Addendum No.3 Bid No.070924-New UTK Bldgs. @ Various Elementary Sites

PRE-BID REQUEST FOR INFORMATION LOG

UNIVERSAL TRANSITIONAL
KINDERGARTEN ALPHA, JOHN
PERSHING, VIRGINIA LEE ROSE
ELEMENTARY SCHOOL

Drawings M003 and M401:

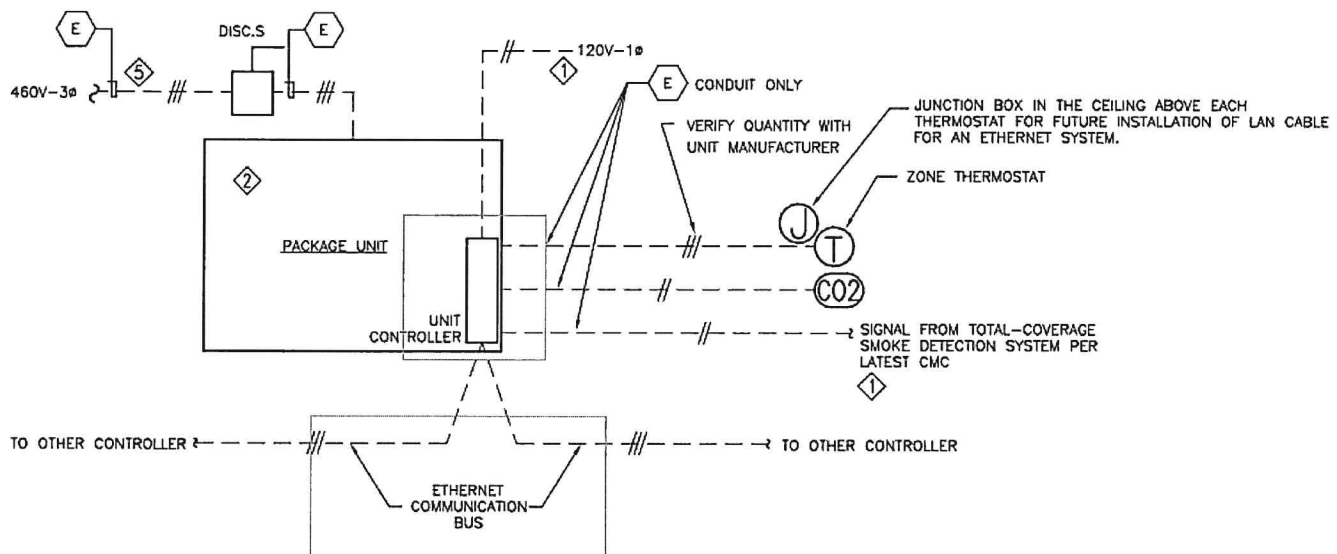
For all three school sites, Alpha, Pershing, and Rose, note #2 of the "Packaged Vertical Unit Schedule" on drawing number M003 calls out the following:

2. PROVIDE PROGRAMMABLE THERMOSTATS. SET POINT AT 74°F. THERMOSTAT WILL BE PROGRAMMED WHEN THE MODULAR BUILDINGS ARE PLACED ON-SITE TO ENSURE THE MINIMUM RATE WILL BE SUPPLIED TO THE SPACE AT ALL USUALLY OCCUPIED TIMES AND PROGRAMMED TO PROVIDE A PRE-OCCUPANT PURGE ONE HOUR PRIOR TO THE MODULAR BUILDING BEING NORMALLY OCCUPIED PER ENERGY CODE 120.14(1). THERMOSTAT SHALL BE ABLE FOR THE ANNUAL OVERRIDE AS NEEDED.

For all three school sites, Alpha, Pershing, and Rose, drawing number M401 calls for the use of an IP (ethernet) Unit Controller/Programmable Logic Controller (PLC) that matches the district's standard. Please see below:

1. PROVIDE CONTROL SYSTEM PER DISTRICT STANDARD FOR EACH UNIT.

Please advise if the "Packaged Vertical Units" should be controlled by "programmable thermostats" or by "unit controllers" connected to the control system per the district's standard.

If "unit controllers" are to be used, please advise the manufacturer and manufacturer's brand of the district's control system standard.

Units should be controlled with programmable thermostats. Use Venstar ColorTouch T8850. See attached photo

Drawings M003 and M401:

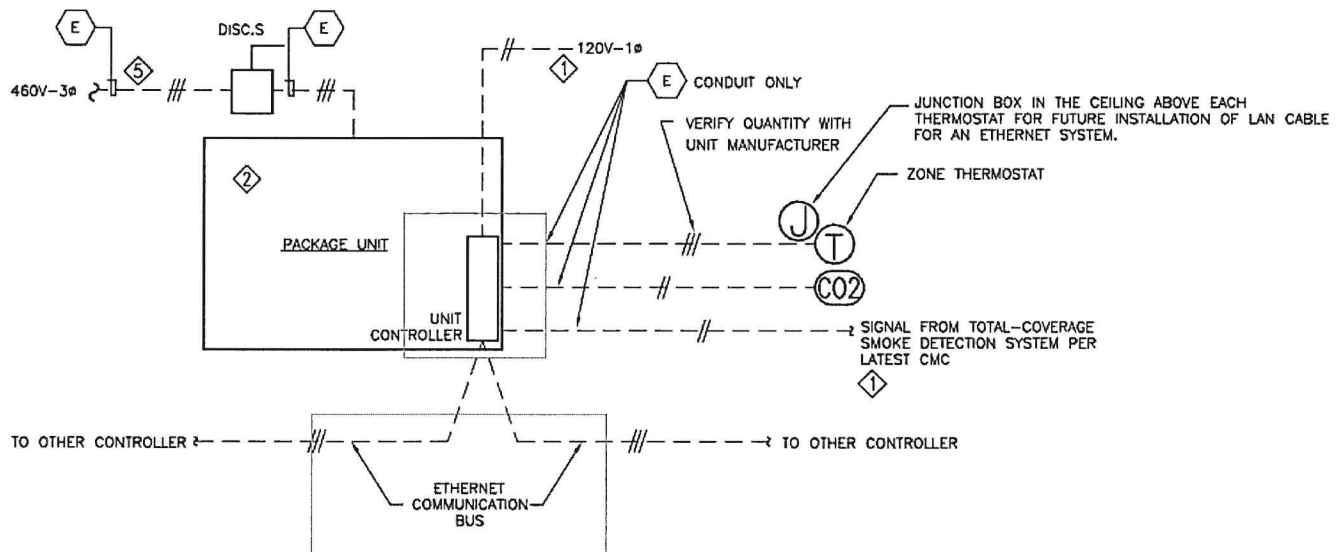
For all three school sites, Alpha, Pershing, and Rose, note #2 of the "Packaged Vertical Unit Schedule" on drawing number M003 calls out the following:

2. PROVIDE PROGRAMMABLE THERMOSTATS SET POINT 1 STAT AT 74°F. THERMOSTAT WILL BE PROGRAMMED WHEN THE MODULAR BUILDINGS ARE PLACED ON A SITE TO ENSURE THE MINIMUM AIR RATE WILL BE SUPPLIED TO THE SPACE AT ALL USUALLY OCCUPIED TIMES AND PROGRAMMED TO PROVIDE A PRE-OCCUPANT PURGE ONE HOUR PRIOR TO THE MODULAR BUILDING BEING NORMALLY OCCUPIED PER ENERGY CODE 120.14(1). THERMOSTAT SHALL BE ABLE FOR THE AIRFUAL OVERRIDE AS FILED.

For all three school sites, Alpha, Pershing, and Rose, drawing number M401 calls for the use of an IP (ethernet) Unit Controller/Programmable Logic Controller (PLC) that matches the district's standard. Please see below:

1. PROVIDE CONTROL SYSTEM PER DISTRICT STANDARD FOR EACH UNIT.

Please advise if the "Packaged Vertical Units" should be controlled by "programmable thermostats" or by "unit controllers" connected to the control system per the district's standard.

If "unit controllers" are to be used, please advise the manufacturer and manufacturer's brand of the district's control system standard.

Units should be controlled with programmable thermostats. Use Venstar ColorTouch T8850. See attached photo
